R12VT

This notice is sent to you in accordance with the requirements of the National Traffic and Motor Vehicle Safety Act. Blue Bird Corporation has decided that a defect which relates to motor vehicle safety exists in certain 2013 model year Vision model conventional school buses manufactured from August 27, 2012 through November 06, 2012.

Drag Link Castle Nut Torque

Models Affected: Certain 2013 Model Year Blue Bird Visions

Fig. 1

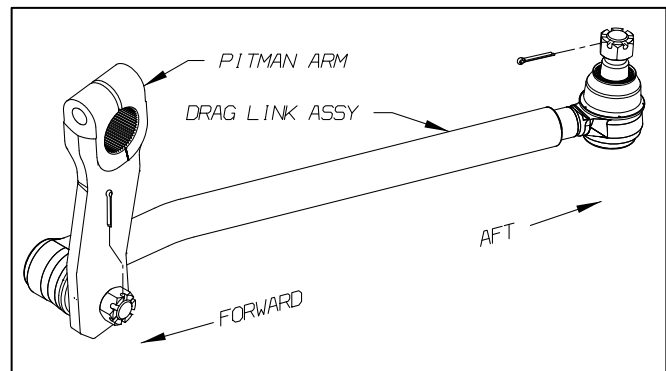
1. Park bus on a level surface, apply parking brake, switch engine off, remove ignition key and chock wheels.
2. Remove cotter pin from ball stud on forward (pitman arm) end of drag link. (Fig. 1)
3. Torque castle nut on drag link ball stud to 160-170 ft-lbs.
4. Re-install cotter pin. If castle nut slot for cotter pin does not line up with through hole in ball stud, tighten castle nut until next slot aligns with through hole. Install cotter pin & bend-over pin tails.
5. Remove cotter pin from ball stud on aft (steer arm) end of drag link. (Fig. 1)
6. Torque castle nut on drag link ball stud to 160- 170 ft-lbs to fully seat ball stud in steer arm.
7. Loosen aft castle nut approximately 6-8 turns.

WARNING: Do NOT loosen castle nut to line up slot with through hole in ball stud. Always tighten castle nut to align slot with through hole.

Fig. 2

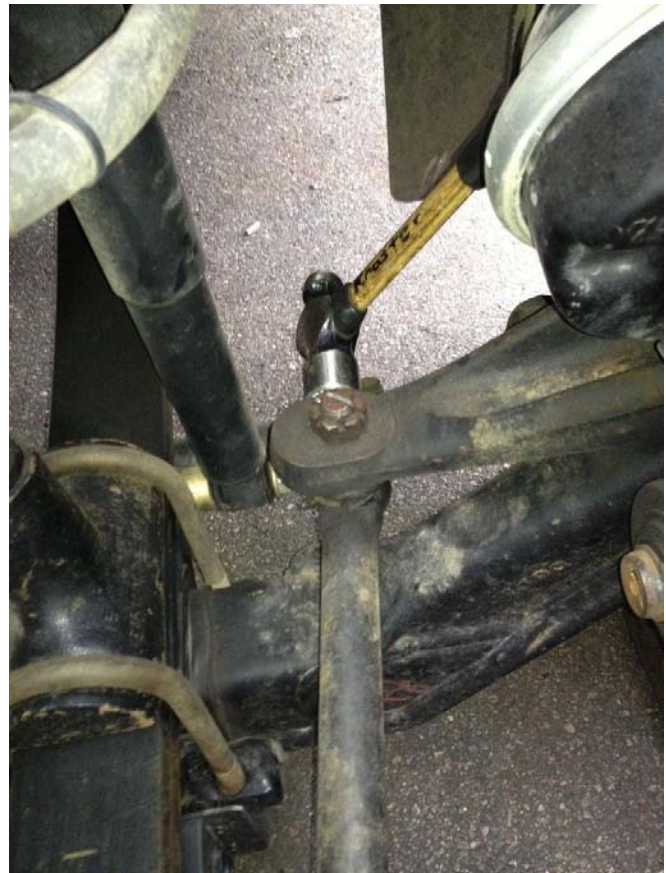
8. Using a 2 lb. ball peen hammer, strike sides of steer arm with two, firm, horizontal blows. Once in each direction.
(Fig. 2 & 3)

NOTE: Castle nut on aft drag link ball stud *MUST* be torqued then loosened 6-8 turns before striking steer arm.

9. If ball stud taper drops out of steer arm after one or two blows, then steer arm tapered hole is damaged. Skip to step 13 and replace steer arm (upper steering knuckle).
10. If ball stud taper remains firmly seated in steer arm after two blows, joint is ok.
11. Torque castle nut on drag link ball stud to 160-170 ft-lbs.
12. Re-install cotter pin. If castle nut slot for cotter pin does not line up with through hole in ball stud, tighten castle nut until next slot aligns with through hole. Install cotter pin & bend-over pin tails. This completes the corrective action.

Fig. 4

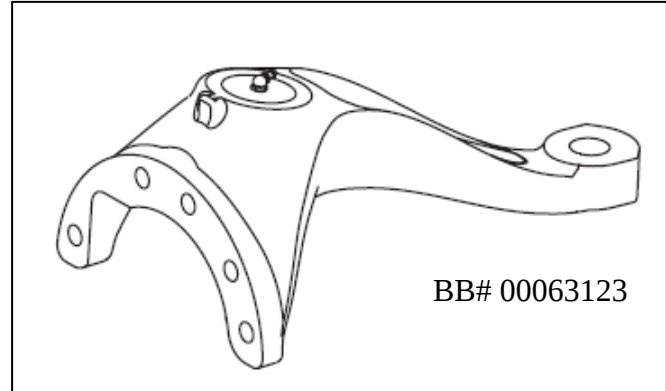
13. Replace axle mounted steer arm, BB# 00063123 (upper steering knuckle) per procedure outlined in BBCV service manual (Front Axle & Suspension, Appendix 1 of BBCV Vision Service Manual, Volume 1).

NOTE: Steer arm (Fig. 4) will come complete with kingpin bushing installed and reamed to correct size. Skip steps in service manual that detail KINGPIN MEASUREMENT, KINGPIN BUSHING REMOVAL, STEERING KNUCKLE BORE MEASUREMENT, KINGPIN BUSHING INSTALLATION, KINGPIN BUSHING REAMING, KINGPIN SEAL INSTALLATION.

14. Re-insert drag link ball stud into newly installed steering arm.
15. Torque castle nut on drag link ball stud to 160-170 ft-lbs.
16. Re-install cotter pin. If castle nut slot for cotter pin does not line up with through hole in ball stud, tighten castle nut until next slot aligns with through hole. Install cotter pin & bend-over pin tails. This completes the corrective action.
